LANDING GEAR - LANDING GEAR WARNING HORN REPLACEMENT

The original landing gear warning horn is no longer available. If the landing gear warning horn needs to be replaced, a new landing gear warning horn is available and will require an additional bracket for installation.

MEB-32-03
Page 1 of 31

Figure 5. Group B Configuration 2 (Sheet 1)

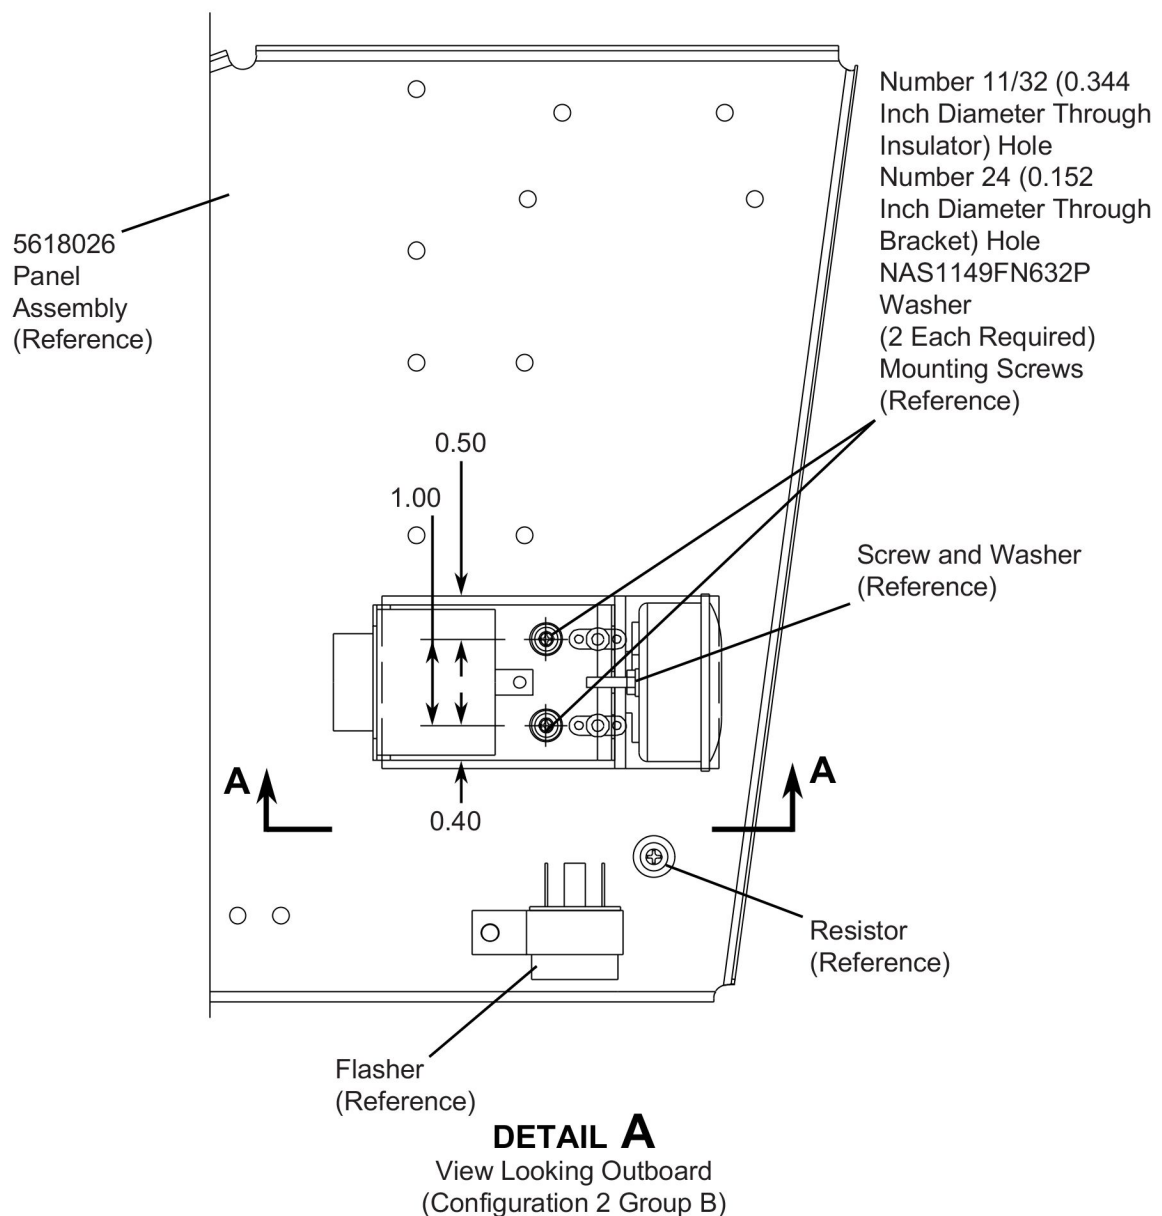
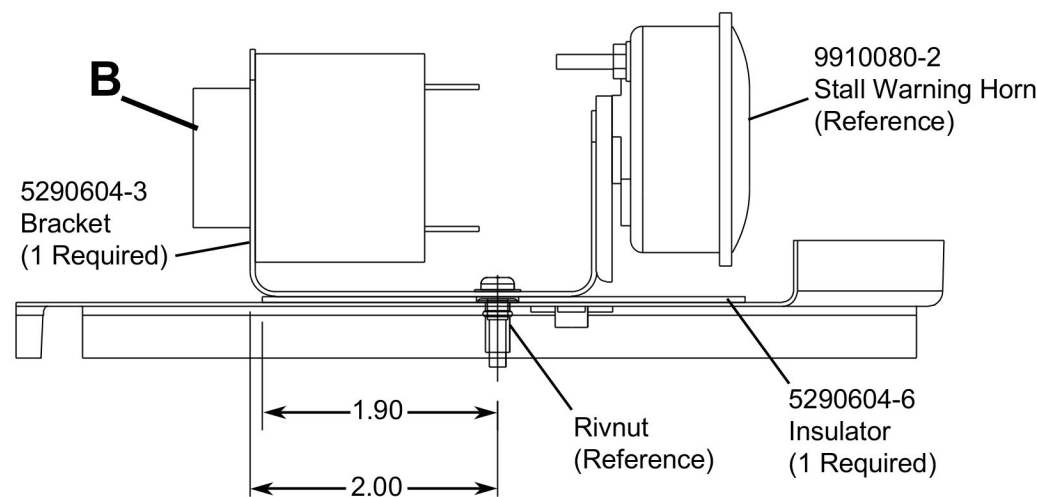
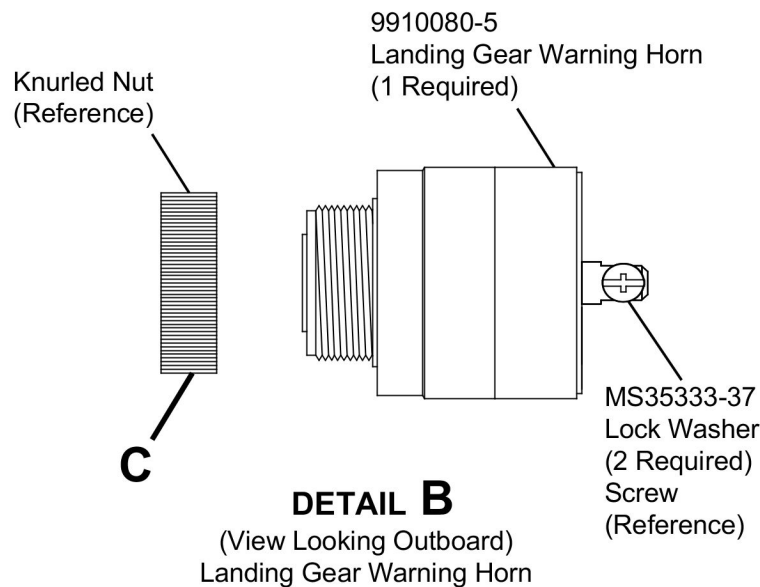
20. (Refer to Figure 5, Sheet 1 and 2.) Install the 9910080-5 Landing Gear Warning Horn as follows:
 - A. Match drill the two new holes of the 5618026 Panel Assembly to a Number 11/32 (0.344 inch diameter) holes into the 5290604-6 Insulator.

- (1) Deburr the drilled holes from the 5290604-6 Insulator.
 - B. Match drill the two new holes of the 5618026 Panel Assembly to a Number 24 (0.152 inch diameter) holes into the 5290604-3 Bracket.

- (1) Deburr the drilled holes from the 5290604-3 Bracket.
 - (2) Apply Color Chemical Film Treatment to all bare metal.
 - C. Install the 5290604-3 Bracket and the 5290604-6 Insulator into the rivnuts of the 5618026 Panel Assembly with the two kept mounting screws and the two NAS1149FN632P Washers.

NOTE: The plastic knurled nut must be installed with the three indents toward the bracket and horn assembly. On the internal circumference, the smooth side without threads is installed first, towards the bracket and horn. This technique of installation will make sure the nut fully seats against the bracket and not bottom-out on the threads. If not installed correctly the knurled nut will bottom-out on the threads and the horn assembly will not be fully tightened in the bracket.
 - F. Install the labeled electrical wiring, screws, and the two MS35333-37 Lock Washers into the 9910080-5 Landing Gear Warning Horn.

Figure 6. Group A Before Configuration 3 Modification (Sheet 1)

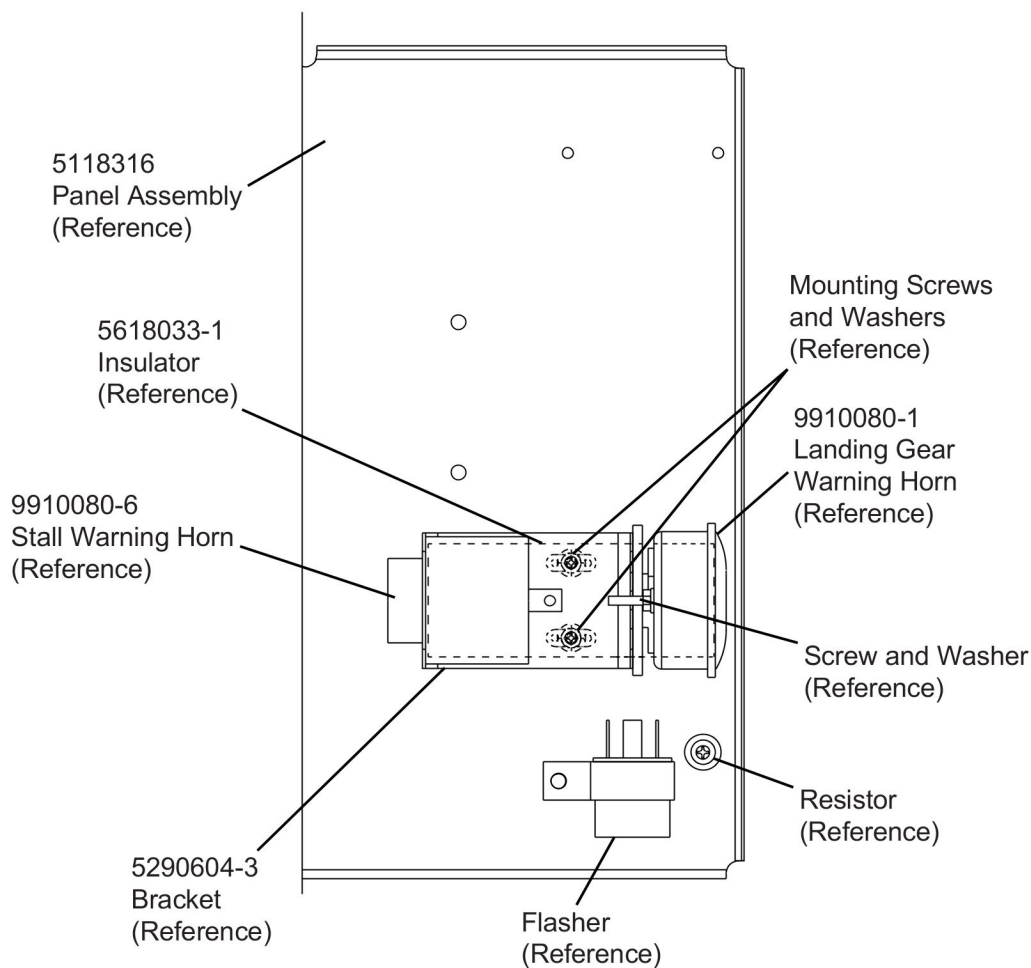
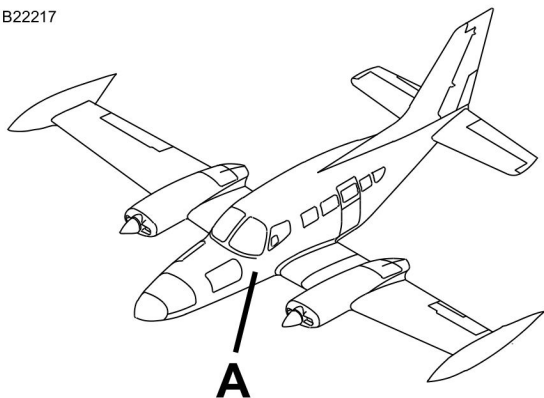
25. (Refer to Figure 6, Sheet 1.) Remove the 5290604-3 Bracket as follows:
- A. Remove and discard the screw and lock washer from the 9910080-1 Landing Gear Warning Horn.
 - B. Disconnect and label the electrical wiring from the 9910080-1 Landing Gear Warning Horn.
 - C. Discard all electrical hardware from the 9910080-1 Landing Gear Warning Horn.
 - D. Discard the 9910080-1 Landing Gear Warning Horn.
 - E. Remove and keep the 9910080-6 Stall Warning Horn.
- NOTE:** The kept 9910080-6 Stall Warning Horn will be used during installation.
- F. Remove and keep the two mounting screws and the two washers from the 5290604-3 Bracket.
- NOTE:** The kept mounting screws and washers will be used during installation.
- G. Discard the 5618033-1 Insulator and the 5290604-3 Bracket.

Figure 7. Group A Configuration 3 (Sheet 1)

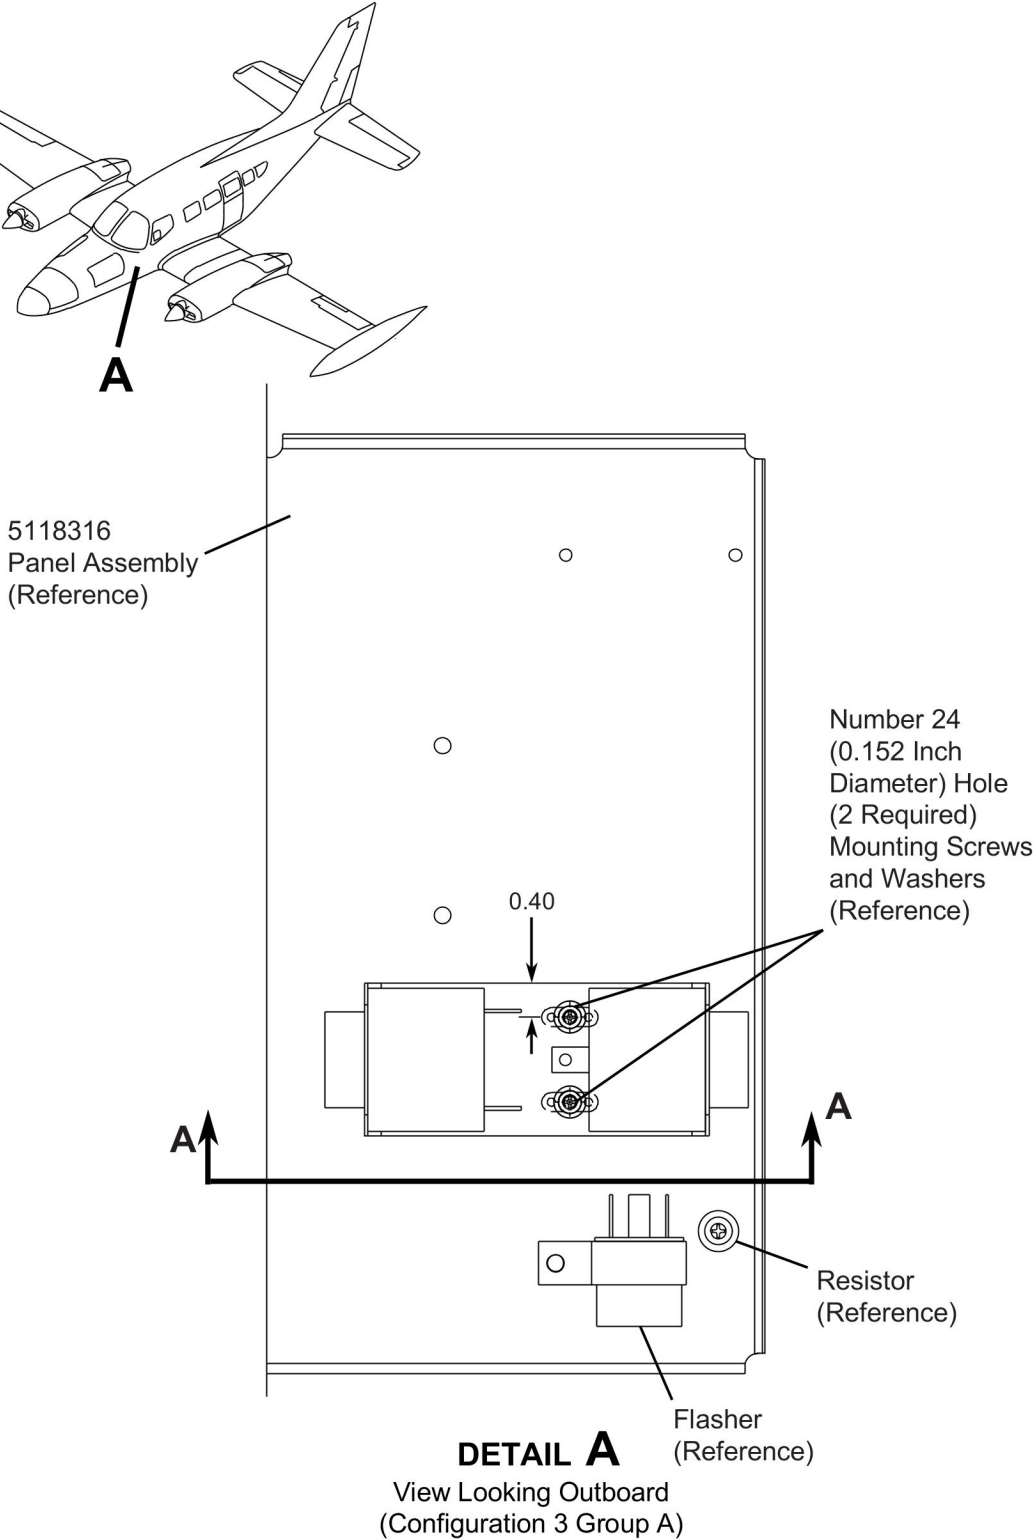
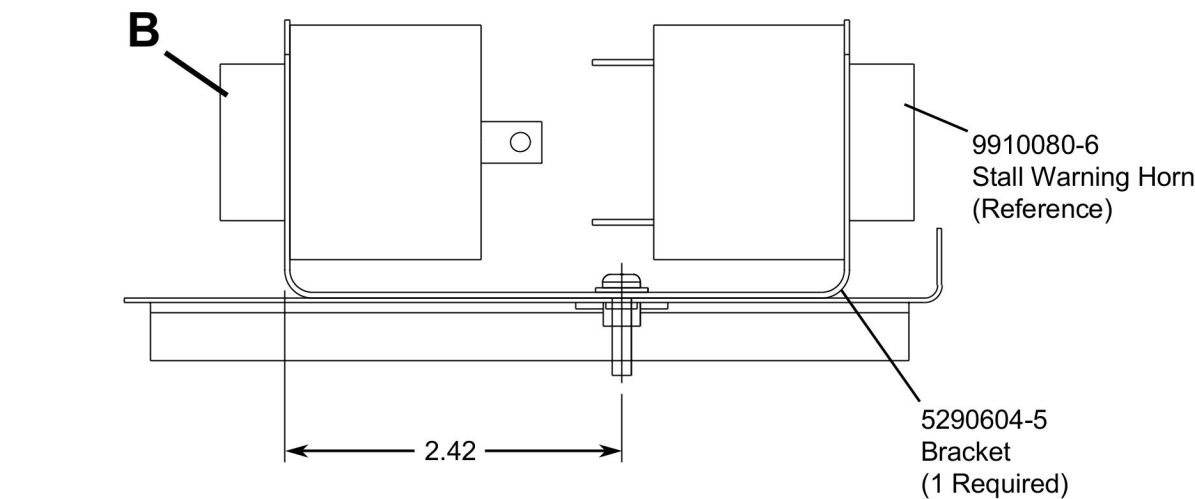
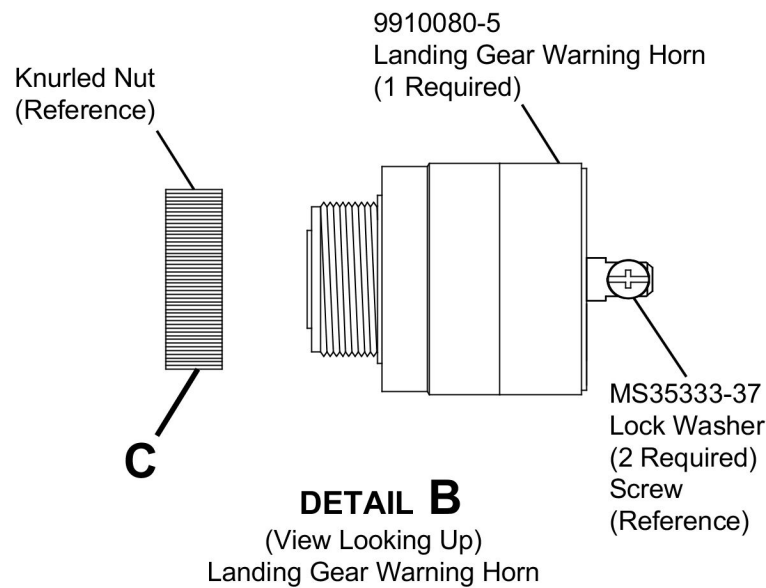
27. (Refer to Figure 7, Sheet 1 and 2.) Install the 9910080-5 Landing Gear Warning Horn as follows:
- A. Match drill the two Number 24 (0.152 inch diameter) holes of the 5118316 Panel Assembly to the 5290604-5 Bracket.

- (1) Debur the drilled holes from the 5290604-5 Bracket.
 - (2) Apply Color Chemical Film Treatment to all bare metal.
 - B. Install the 5290604-5 Bracket with the two kept mounting screws and the two kept washers into the 5118316 Panel Assembly.

- C. Install the 9910080-5 Landing Gear Warning Horn into the 5290604-5 Bracket.
 - D. Install the knurled nut onto the 9910080-5 Landing Gear Warning Horn.

- NOTE:** The plastic knurled nut must be installed with the three indents toward the bracket and horn assembly. On the internal circumference, the smooth side without threads is installed first, towards the bracket and horn. This technique of installation will make sure the nut fully seats against the bracket and not bottom-out on the threads. If not installed correctly the knurled nut will bottom-out on the threads and the horn assembly will not be fully tightened in the bracket.

Figure 8. Group B Before Configuration 3 Modification (Sheet 1)

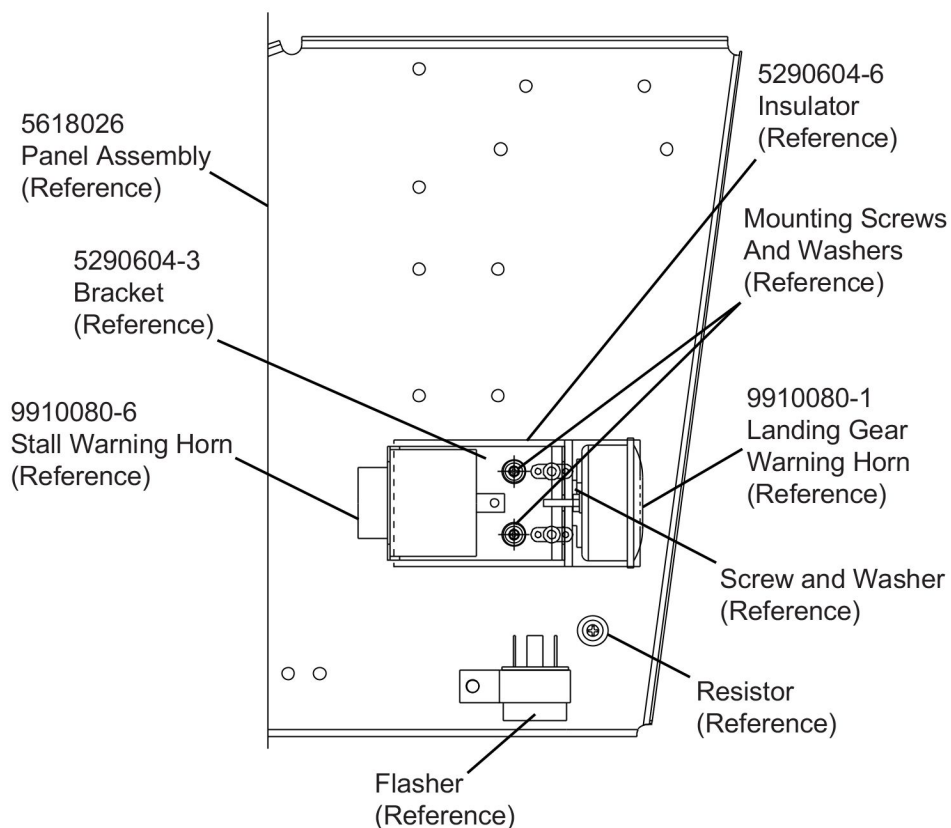
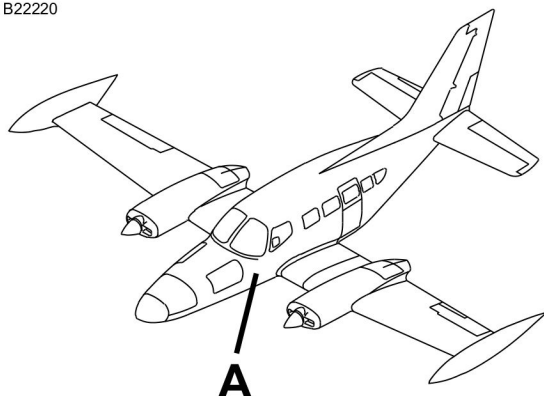
- 32. (Refer to Figure 8, Sheet 1.) Remove the 5290604-3 Bracket as follows:
 - A. Remove and discard the screw and lock washer from the 9910080-1 Landing Gear Warning Horn.
 - B. Disconnect and label the electrical wiring from the 9910080-1 Landing Gear Warning Horn.
 - C. Discard all electrical hardware from the 9910080-1 Landing Gear Warning Horn.
 - D. Discard the 9910080-1 Landing Gear Warning Horn.
 - E. Remove and keep the 9910080-6 Stall Warning Horn.

NOTE: The kept 9910080-6 Stall Warning Horn will be used during installation.
 - F. Remove and keep the two mounting screws and the two washers from the 5290604-3 Bracket.
 - G. Remove and keep the 5290604-6 Insulator.

Figure 9. Group B Configuration 3 (Sheet 1)

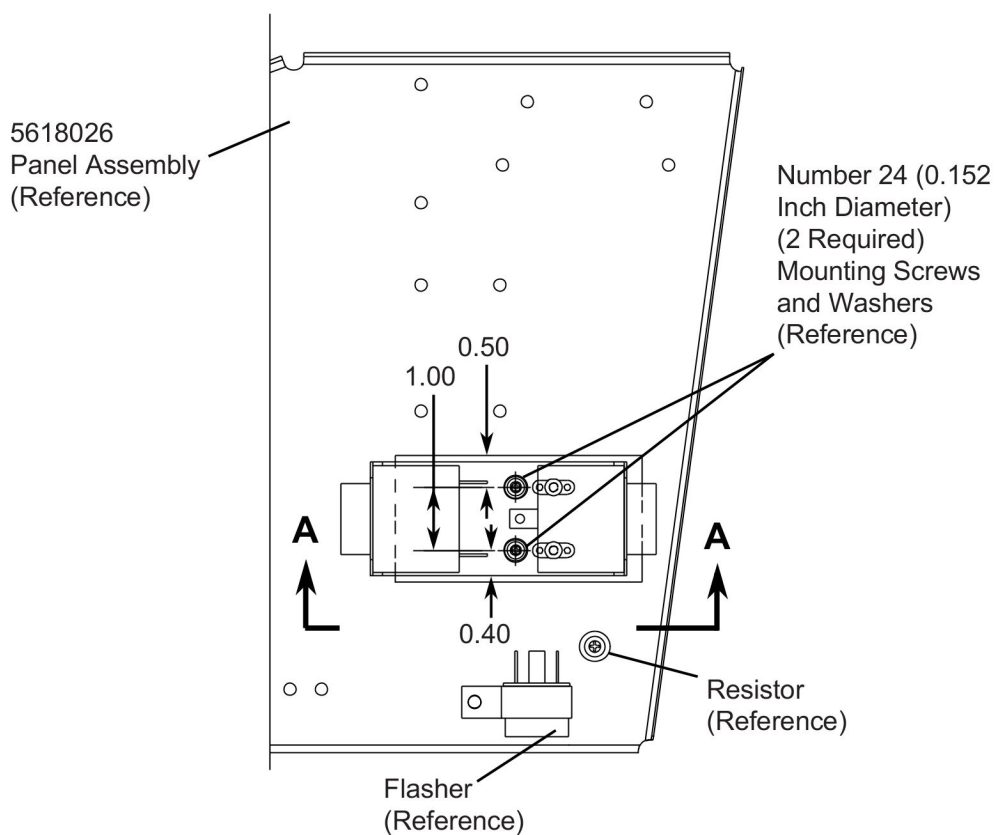
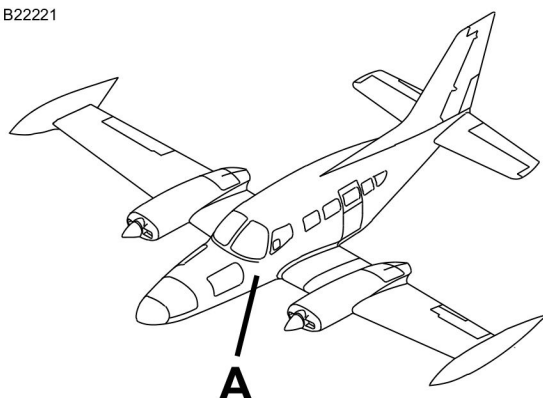
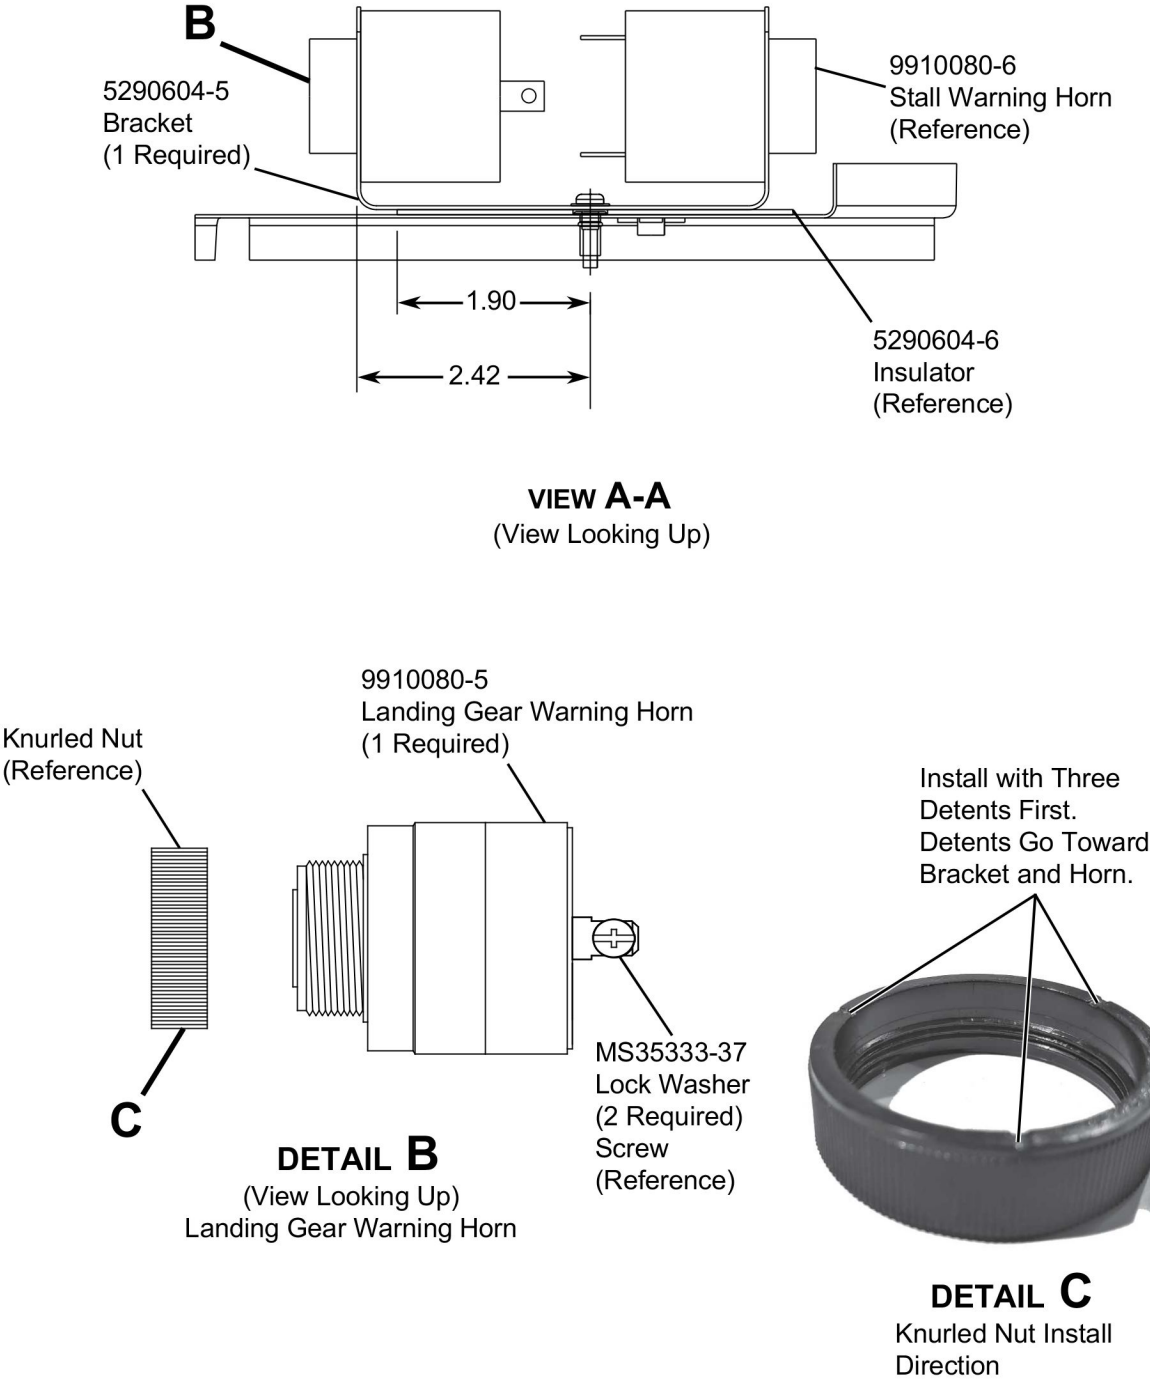
34. (Refer to Figure 9, Sheet 1 and 2.) Install the 9910080-5 Landing Gear Warning Horn as follows:
- A. Match drill the two Number 24 (0.152 inch diameter) holes of the 5618026 Panel Assembly to the 5290604-5 Bracket.
 - (1) Debur the drilled holes from the 5290604-5 Bracket.
 - (2) Apply Color Chemical Film Treatment to all bare metal.
 - B. Install the 5290604-5 Bracket and the kept 5290604-6 Insulator into the rivnuts of the 5118316 Panel Assembly with the two kept mounting screws and the two kept washers.
 - C. Install the 9910080-5 Landing Gear Warning Horn into the 5290604-5 Bracket.
 - D. Install the knurled nut onto the 9910080-5 Landing Gear Warning Horn.

NOTE: The plastic knurled nut must be installed with the three indents toward the bracket and horn assembly. On the internal circumference, the smooth side without threads is installed first, towards the bracket and horn. This technique of installation will make sure the nut fully seats against the bracket and not bottom-out on the threads. If not installed correctly the knurled nut will bottom-out on the threads and the horn assembly will not be fully tightened in the bracket.
 - E. Install the labeled electrical wiring, screws, and the two MS35333-37 Lock Washers into the 9910080-5 Landing Gear Warning Horn.
